Recycling & Recovery

RE: SSD7267 Mod 2 - Response to Submissions

Re: SSD 7267 Wetherill Park Transfer Station, – Civil Engineering Design

**RE: FIRE ENGINEERING BRIEF QUESTIONNAIRE – SUEZ WETHERILL PARK
RESOURCE RECOVERY FACILITY – 20 DAVIS ROAD WETHERILL PARK**

Figure 7: Part Site Plan – Fire Sprinkler System

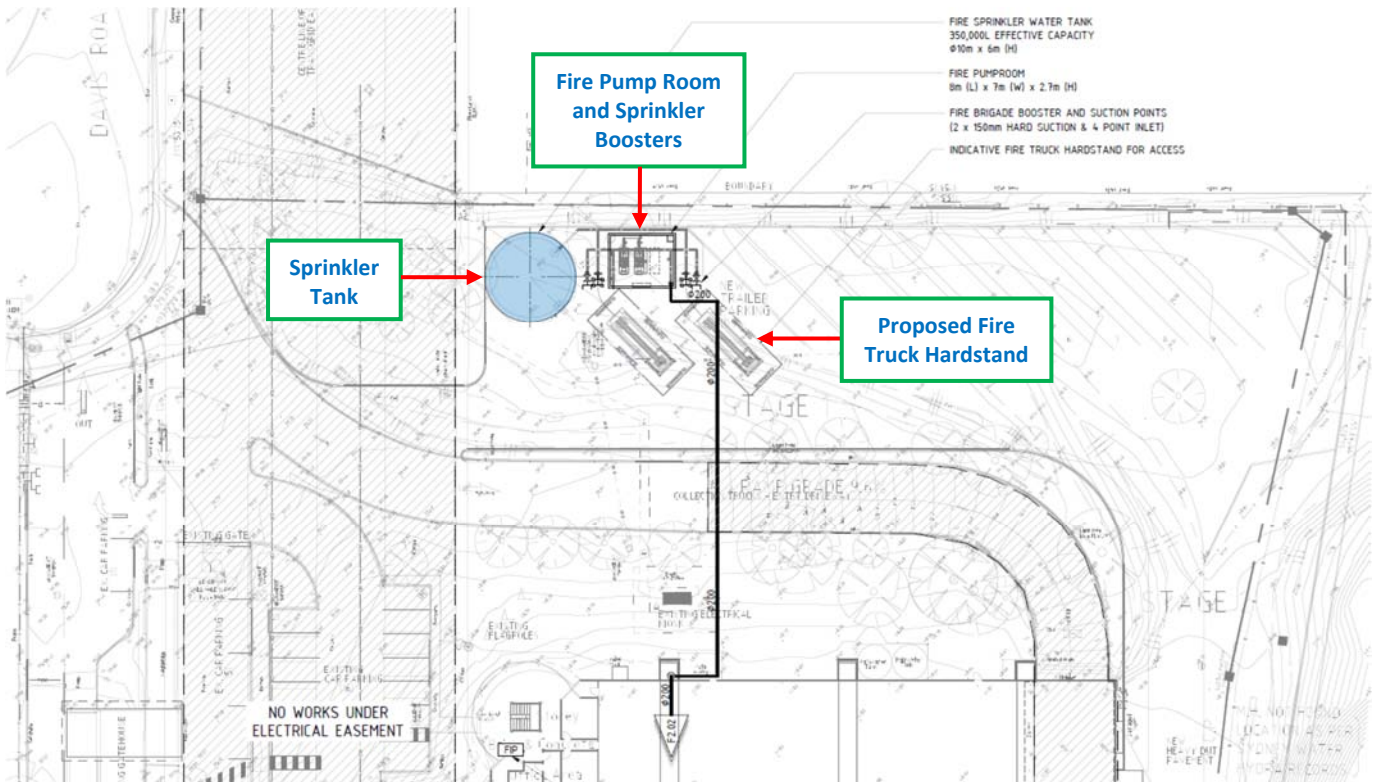
Note to FRNSW: We request FRNSW to advise / confirm that the proposed location of the hardstand for the fire brigade pumping appliances will meet the operational requirements of FRNSW. In principle support is provided

Figure 8: Part Site Plan – Fire Hydrant System

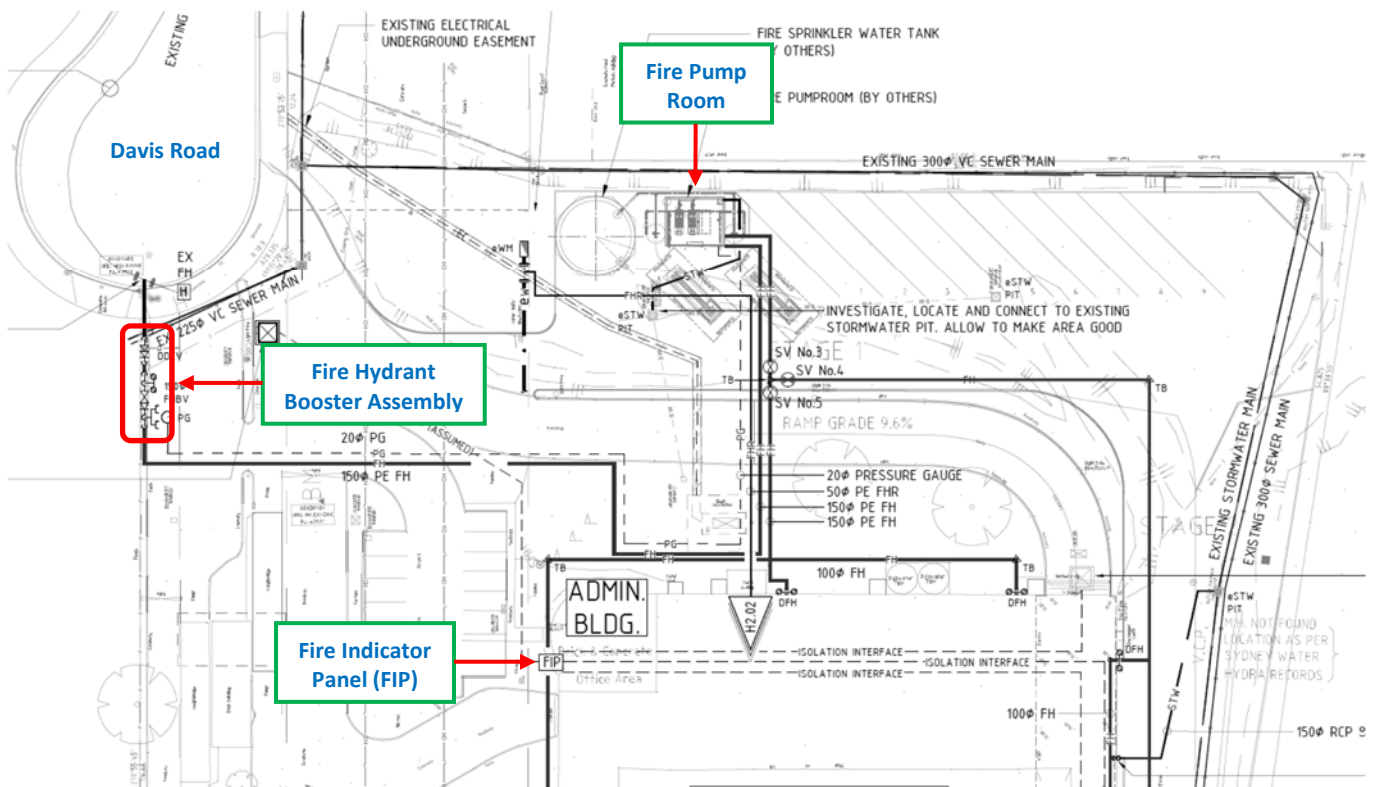
Note to FRNSW: We request FRNSW to advise / confirm whether the location and / or orientation of the fire hydrant booster assembly as shown in Figure 8 will meet the operational requirements of FRNSW. The booster assembly will be orientated to be perpendicular to the Davis Road frontage, but parallel to the perimeter access road around the building.

Figure 11: Proposed Staging Plan

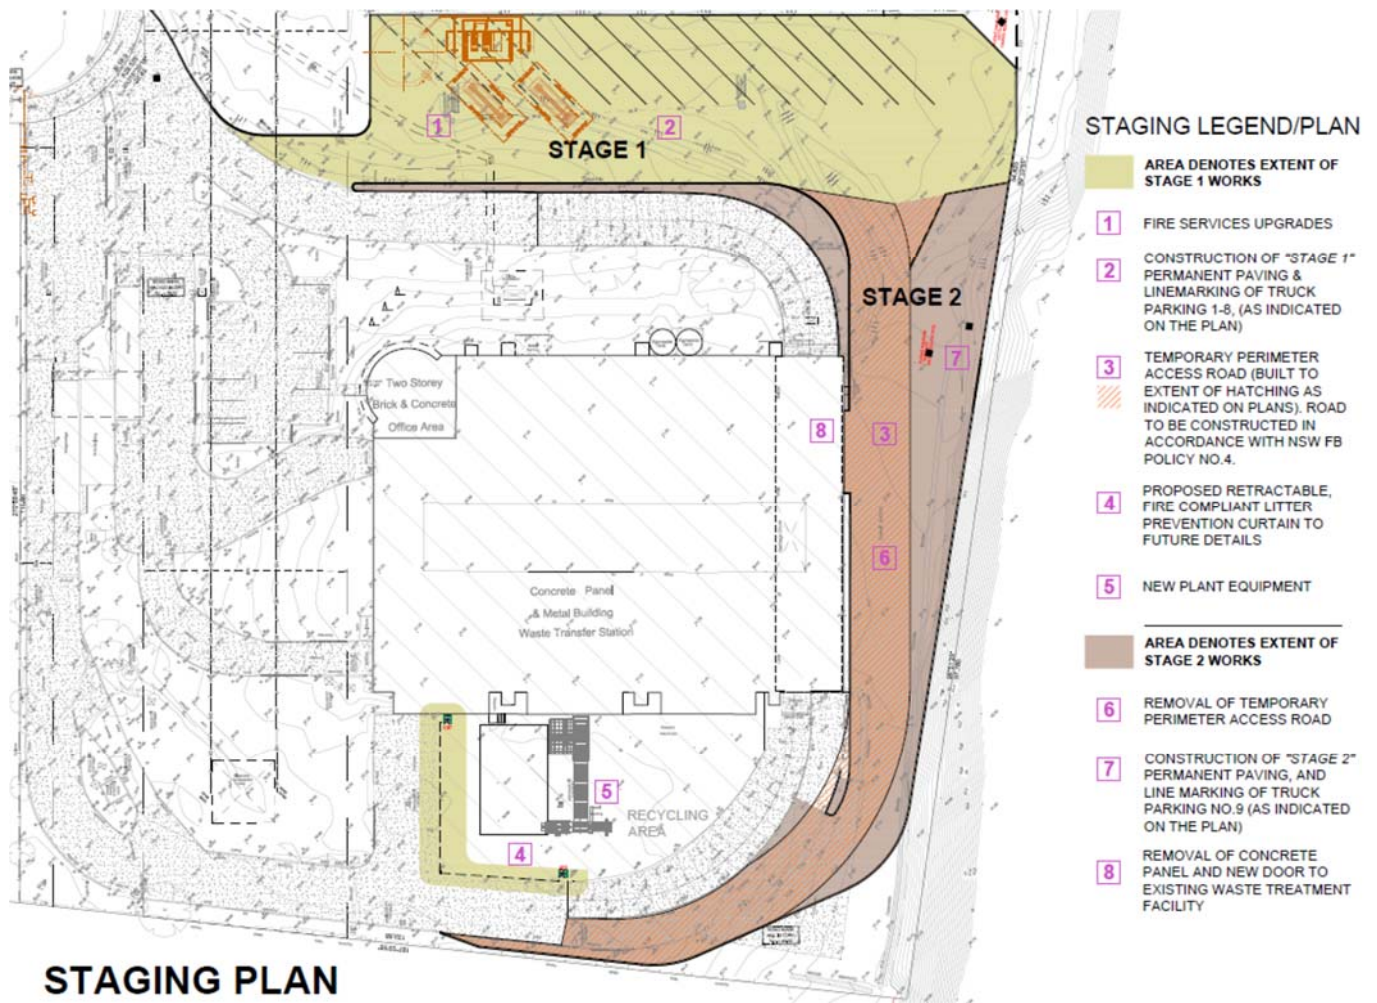
Note to FRNSW: The development works will be completed in 2 Stages. At the completion of Stage 1, part of the perimeter vehicle access road around the site will not comprise a ‘sealed’ road. However, the perimeter access road will be trafficable and will be designed to ensure it is capable of supporting the static and dynamic loads of fire brigade appliances as detailed within the NSW Fire Brigades Policy No. 4.

The Stage 2 works will include upgrading of this part of the perimeter access road so that it is sealed throughout. The extent of the Stage 2 works is illustrated in Figure 11.
